#### HISTORIC AND DESIGN REVIEW COMMISSION

**HDRC CASE NO:** 2015-114

**ADDRESS:** 126 W AGARITA AVE

**TYPE OF WORK:** Front and rear yard landscaping, hardscaping and irrigation

L A N D S C A P E
D E S I G N
F O R
L E E
R E S I D E N C E

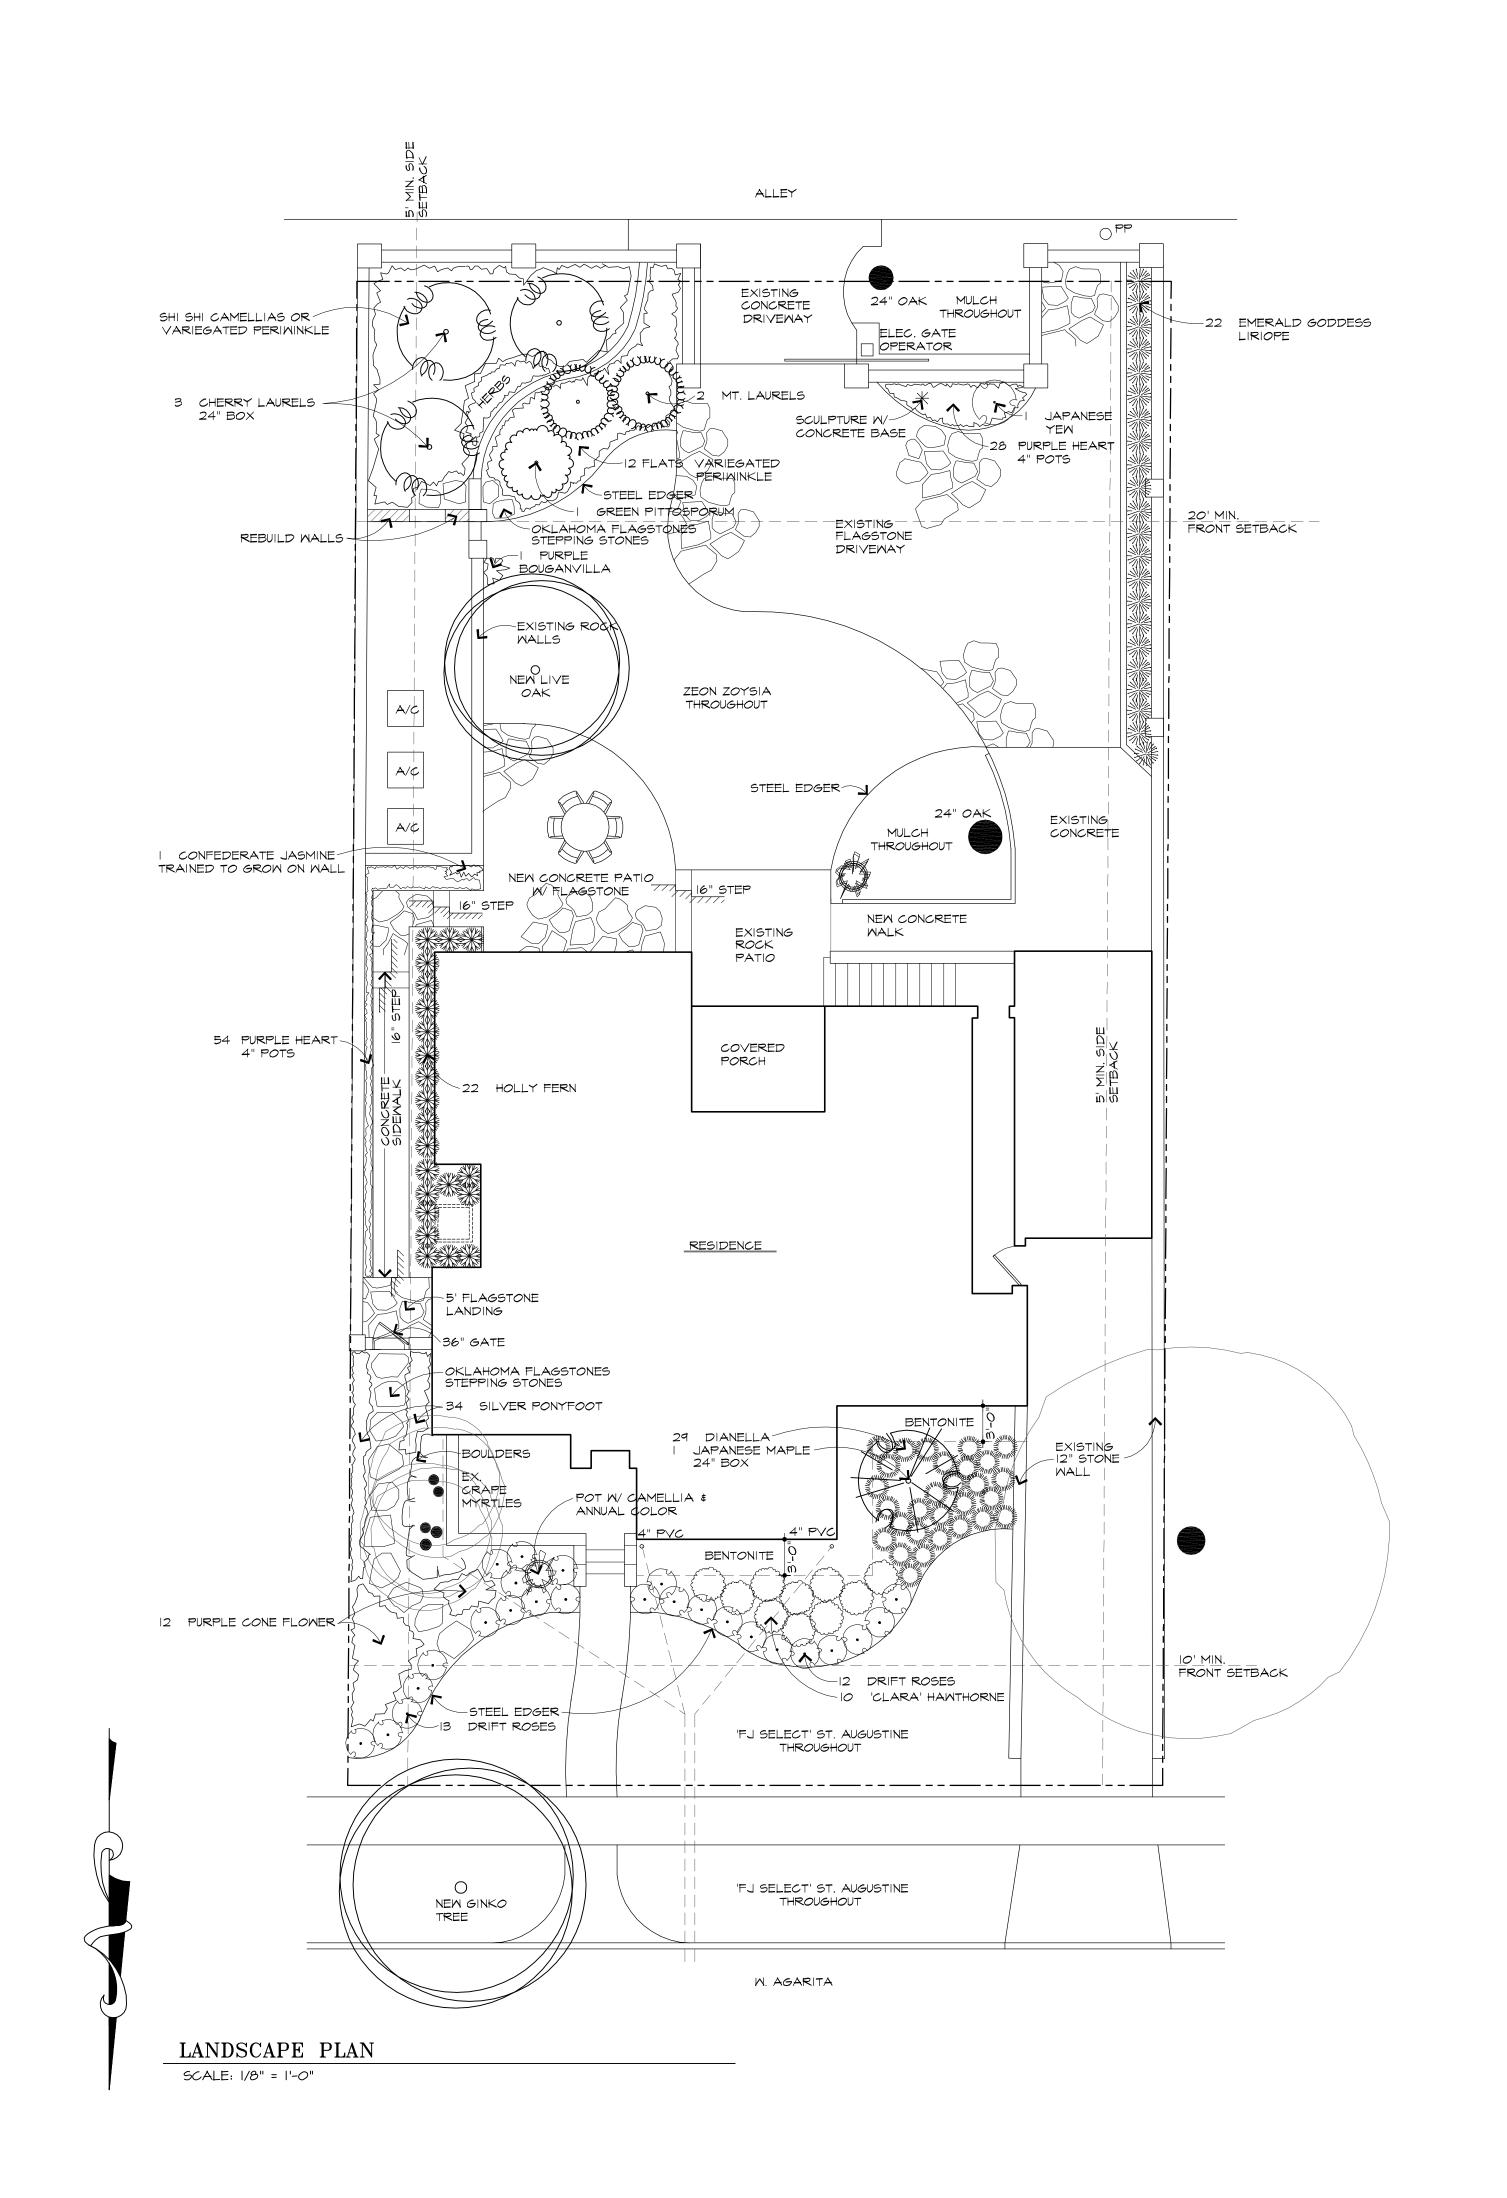
- a. Consistent with the Guidelines for Site Elements, removal of lawn areas should be limited to mulched planting beds in locations where they will be historically found. The proposed mulch beds in the front yard will incorporate various plants and are consistent with the guidelines. However, the proposed mulch area on the rear of the house does not incorporate any plantings which should be avoided.

- b. According to the Guidelines for Site Elements, large areas of impervious hardscape should not be used where not historically located. The proposed hardscape walkway along the side of the house is consistent with the guidelines. However, the proposed new patio, in addition to existing impervious hardscape areas will significantly reduce the pervious areas of the rear yard which should be avoided. Consistent with the Guidelines for Site Elements, historic lawn areas should never be reduced by more than 50%. The total area of proposed and existing hardscape in the rear yard will exceed 50% of the rear yard area. A semi-pervious patio with the stone pavers set

on sand or crushed stone instead of concrete would be more appropriate.

Staff recommends approval based on findings a-b with the following stipulations:

- a. The mulch bed in the rear yard incorporates plantings.
- b. The new flagstone patio is set on sand or crushed stone and not concrete.
